# Intel® Pentium® 4 Processor in 478-pin Package and Intel® 845 Chipset Platform for DDR

Design Guide Update

*March 2004*

Document Number: **298595-003**

### 1. **Replaced: Replace Figure 139, Intel® 845 Chipset Platform Using DDR System Memory Power Delivery Map**

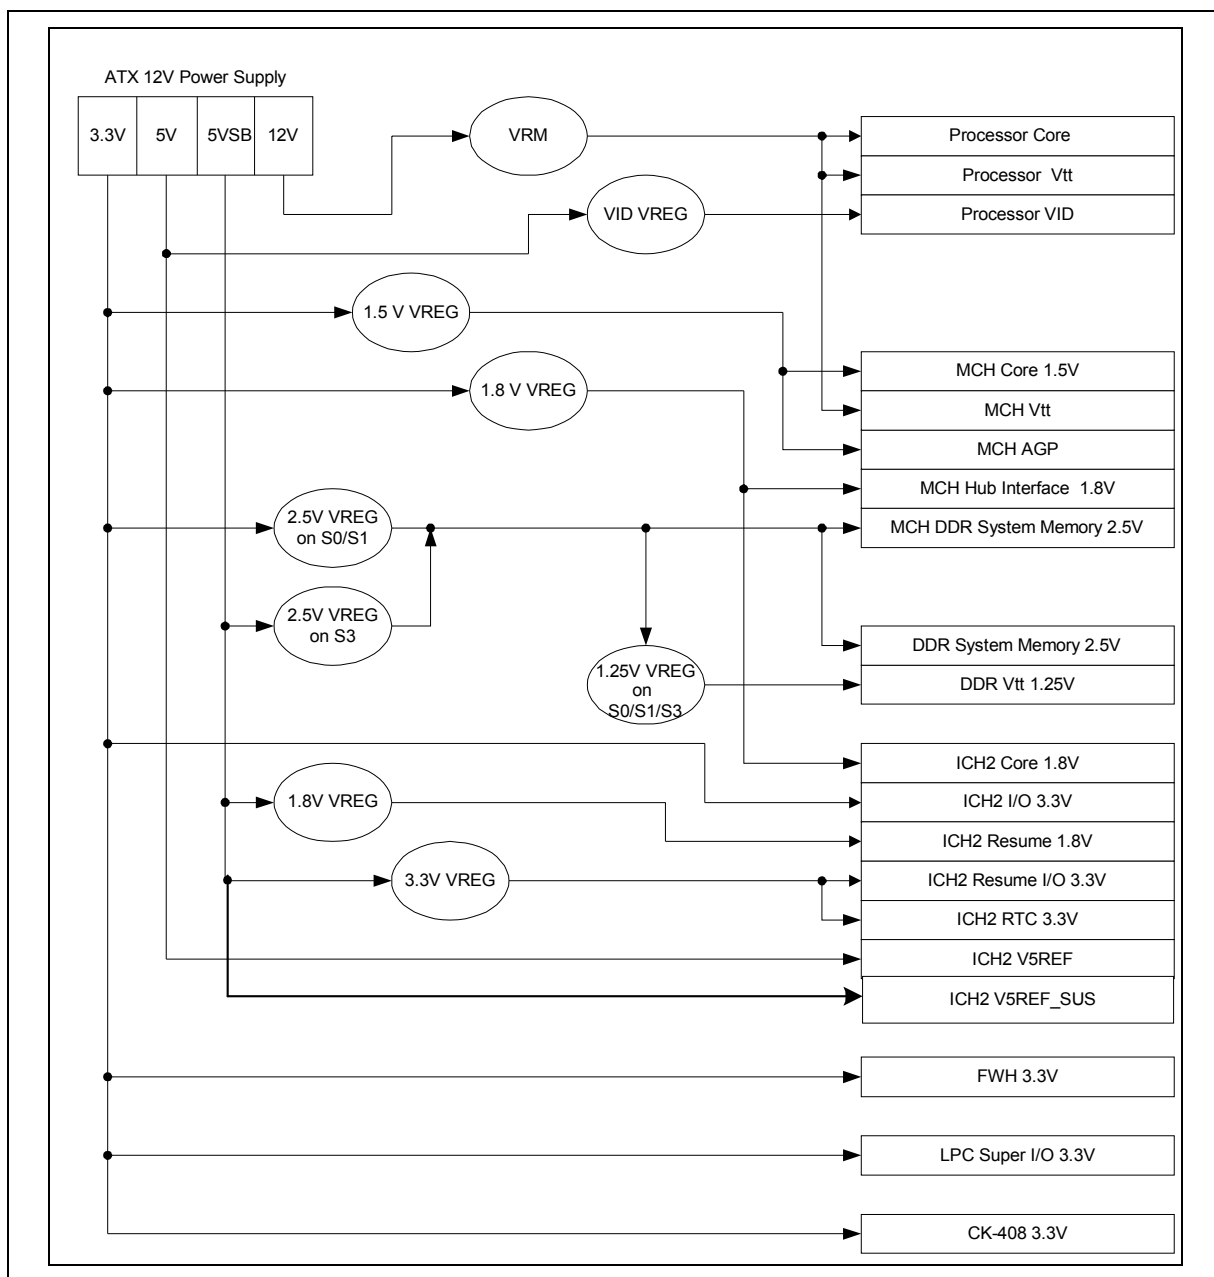
Figure 139, Intel® 845 Chipset Platform Using DDR System Memory Power Delivery Map, in Section 12.2, has two changes in the ICH2 section:

One ICH2 power plane is added to it. This added ICH2 power plane is “ICH2 V5REF\_SUS”. This power plane has always existed in the ICH2. It is not new. This addition to the Power Delivery Map simply shows this ICH2 plane.

The block labeled “ICH2 5 V” is renamed to “ICH2 V5REF”.

These two changes above also reflect the actual pin names on the ICH2.

A third change is that the two, 2.5 V VREG voltage regulators have corrections to the supported system power states (S0, S1, S2, etc.).

A forth change is that the supported system power states for the 1.25 V VREG voltage regulator have been moved inside the ellipse.

Figure 139 is replaced with the following new Power Delivery Map:

**Figure 1. Top Signal Layer before the Ground Fill Near the I/O Area**

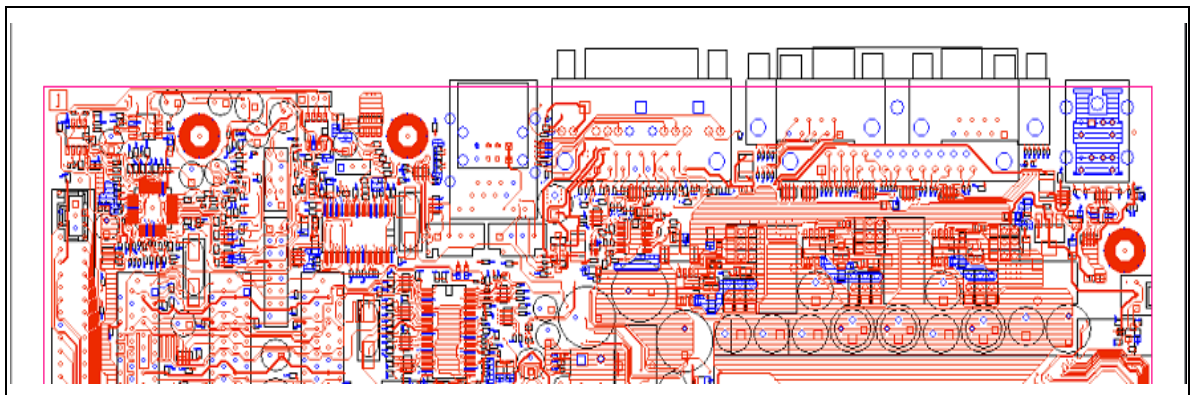
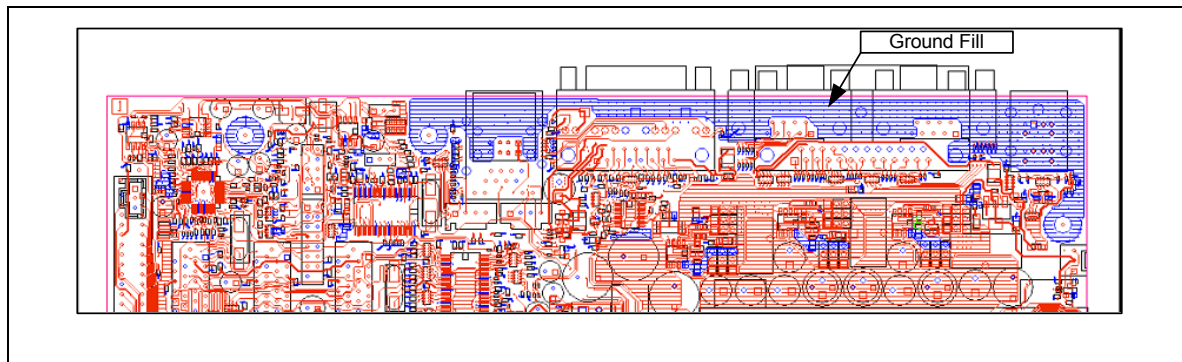
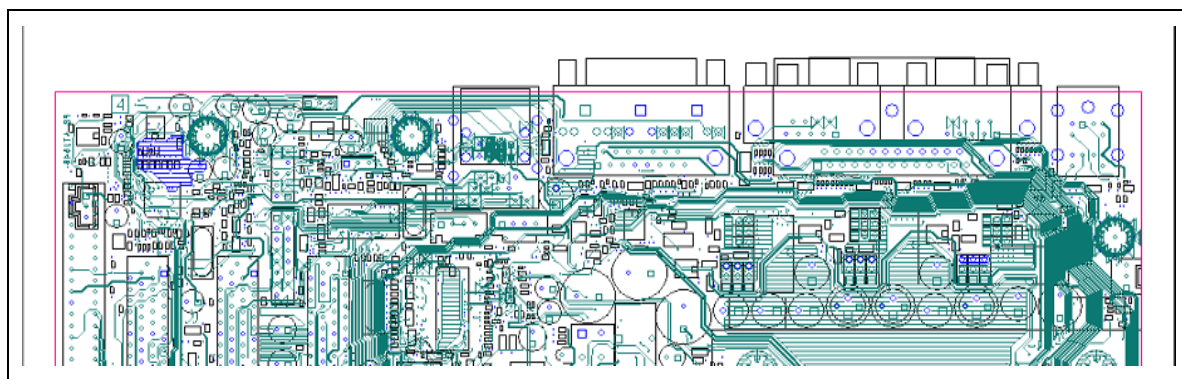
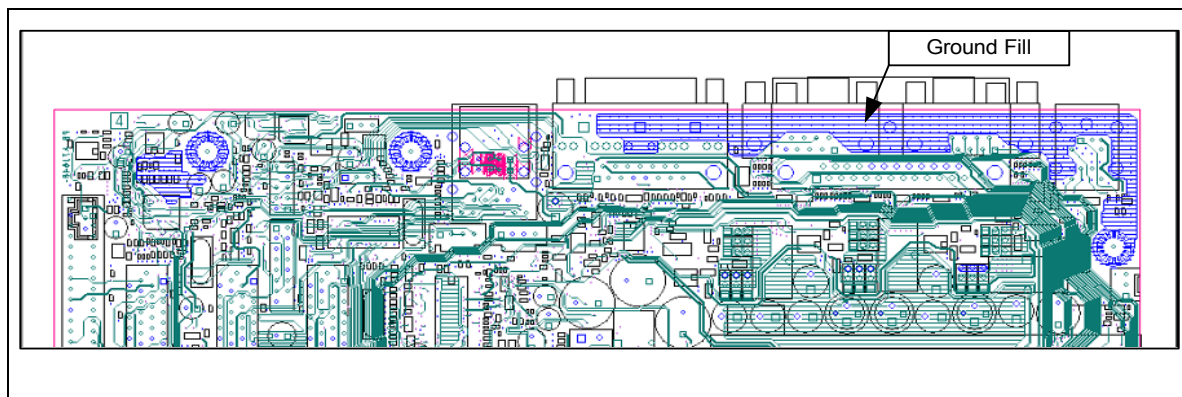
Intel recommends that the I/O area on the top and bottom signal layers of a 4-layer motherboard near the I/O back panel be filled with a ground fill as shown in Figures 1-4. In addition, a ground fill cutout should be placed on the Vcc layer in the area where the ground fill is done on the top and bottom layers. Intel recommends filling the I/O area as much as possible without effecting the signal routing. The board designer should fill the entire I/O area along the board edge.

The spacing from the ground fill to other shapes/traces should be at least 20 mils. It is recommended that these ground fill areas be connected to two chassis mounting holes (as seen in Figure 2). This will allow ESD current to travel to the chassis instead of the board. Ground stitching vias should be placed throughout the entire ground fill if possible. It is important that the vias are placed along the board edge. Ground stitching vias for the ground fill should be 100–150 mils apart or less.

- Fill the I/O area with the ground fill in all layers including signal layers whenever possible.
- Extend the ground fill along the entire back I/O area.
- Connect the ground fill to mounting holes.
- Place stitching vias 100-150 mils apart in the entire ground fill.
